# POWER CABLE DESIGN CHANGED

The 8W0 cable assembly, NSN 5995-01-604-0451, is an important component that connects the M119A3 towed howitzer's fire control computer (FCC) to the artillery power distribution assembly (APDA).

New 8W0 cable assembly...

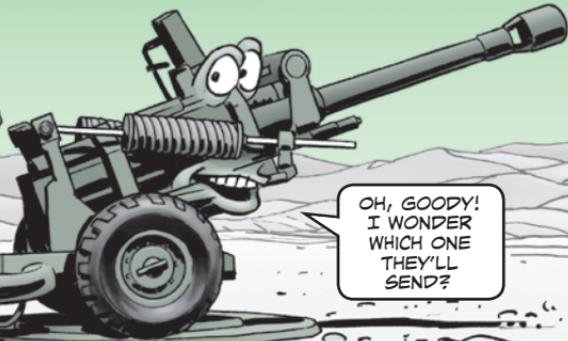
The cable now has a new design, so it looks a little different from the old cable. Which cable you get when you order a replacement depends on what's available in supply.

But don't let that throw you. Both cables work just the same and there's no difference in how the cables are installed or removed.

They look different, but work the same
